APPEAL SUMMARY

Appeal ID: 23492	Project Address: 1336 N Watts St
Hearing Date: 2/26/20	Appellant Name: William Neburka
Case No.: B-006	Appellant Phone: 5035452506
Appeal Type: Building	Plans Examiner/Inspector: Anne Schmidt
Project Type: commercial	Stories: 3 Occupancy: R-2 Construction Type: V-B
Building/Business Name:	Fire Sprinklers: Yes - All
Appeal Involves: Erection of a new structure	LUR or Permit Application No.: 19-190314-CO
Plan Submitted Option: pdf [File 1]	Proposed use: Residential

APPEAL INFORMATION SHEET

Fire Barrier

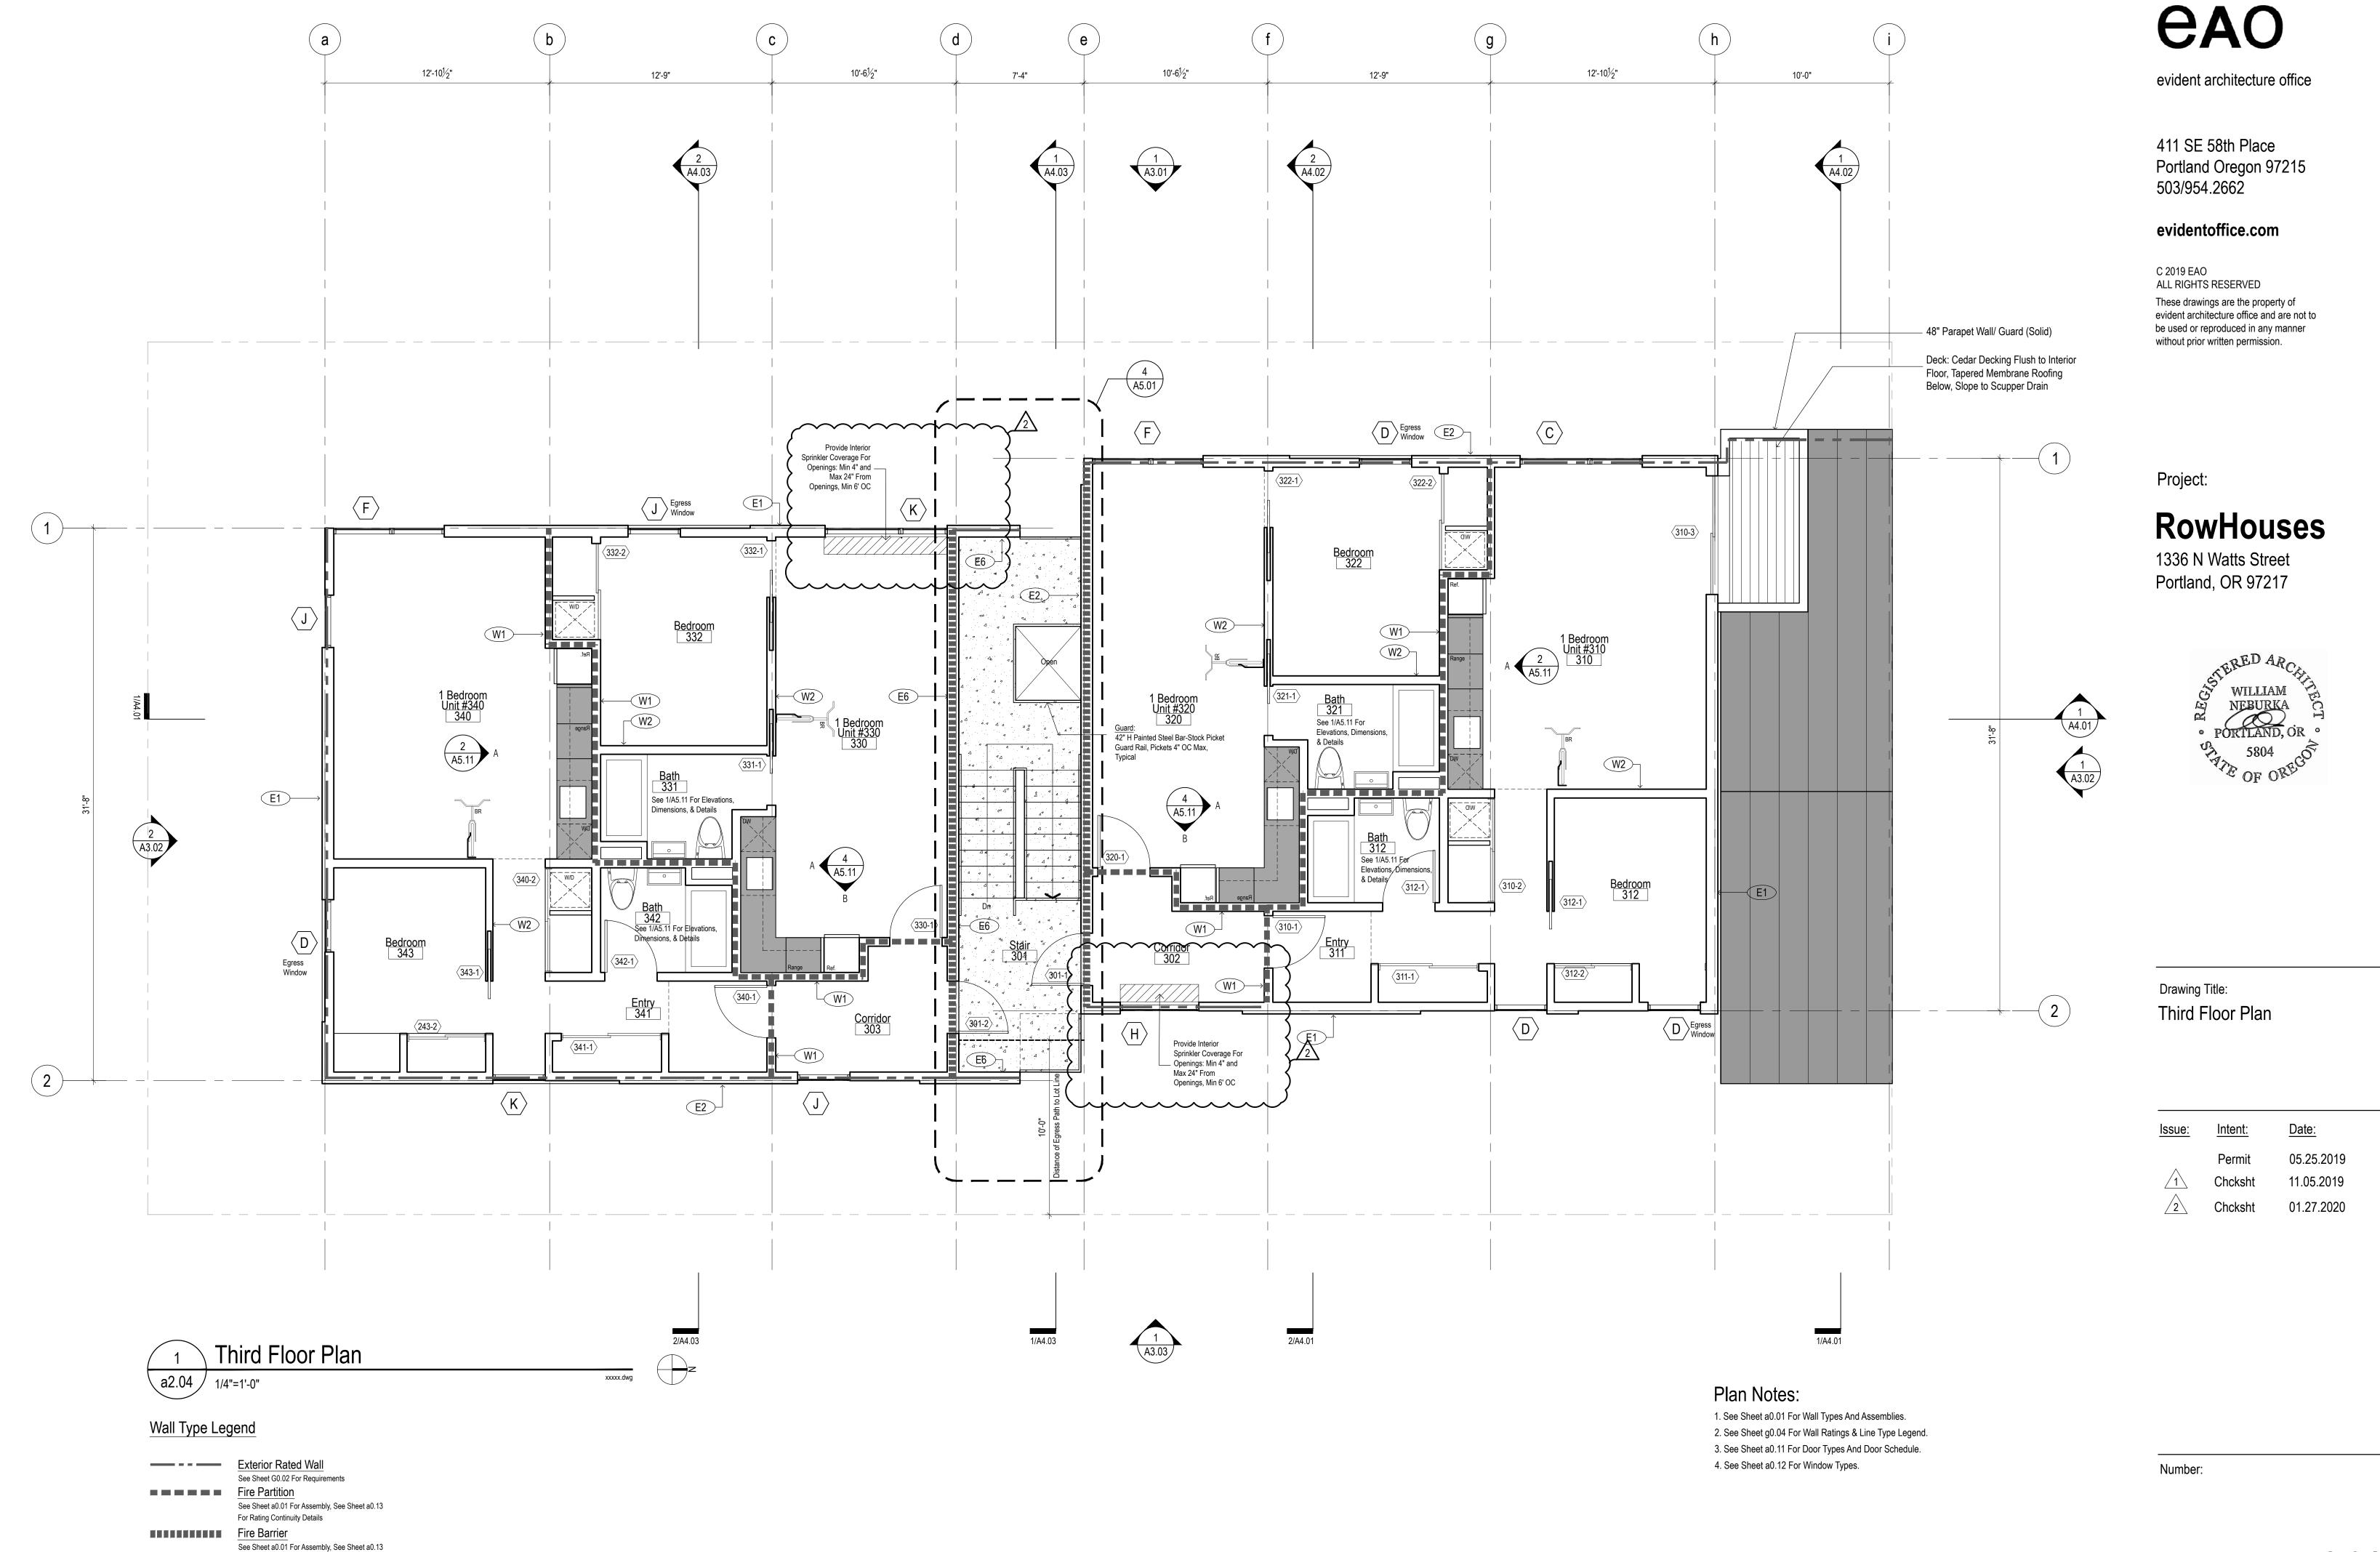
Our project contains a single exterior stairway serving 4 units on 2 floors. The stairway is separated from the occupied space by the required 1hr assembly. At the northeast corner of the stair the exterior wall returns north along the face of the building. We have indicated that the rating extend for 10' northward which contains windows and doors providing light and access to the adjacent tenant spaces. We propose providing fixed window units with tempered glass in these locations and provide a sprinkler head providing coverage at each opening, spaced a minimum of 4" and a maximum of 24" from the glass plane. The city has granted this type of appeal previously on numerous projects.

At the ground floor a single unit entry/egress door falls within the 10' extension of the rated wall. We propose a solid wood frame, single lite entry door with a tempered glass lite and spring-loaded self-closing device.

Where we do not need operable windows for required ventilation or egress, we propose providing conventional fixed window units with tempered glass in these locations, and providing sprinkler head coverage at each opening, spaced a minimum of 4" and a maximum of 24" from the glass plane. The city has granted this type of appeal previously on numerous projects.

Where unit entry/egress doors fall within this adjacency requiring protection, we propose We propose solid wood frame, single lite entry doors with a tempered glass lite and spring-loaded selfclosing device.

1. Type 13 water curtain sprinkler protection at non-fire rated openings in exterior walls within 180 degrees of exit stair: Granted provided windows are non-operable and sprinklers are spaced not more than 6 feet apart and placed a minimum of 6 inches and a maximum of 12 inches from the opening(s) and a maximum of 12 inches below the ceiling. Sprinklers are to be installed on the occupied side of the openings. A separate permit from the Fire Marshal's Office is required.

- 2. Type 13 water curtain sprinkler protection at non-fire rated openings in buildings with vertical exposure on separate lots: Granted provided;
- a. Windows are non-operable and sprinklers are spaced not more than 6 feet apart and placed a minimum of 6 inches and a maximum of 12 inches from the opening(s) and a maximum of 12 inches below the ceiling. Sprinklers are to be installed on the occupied side of the openings. A separate permit from the Fire Marshal's Office is required.
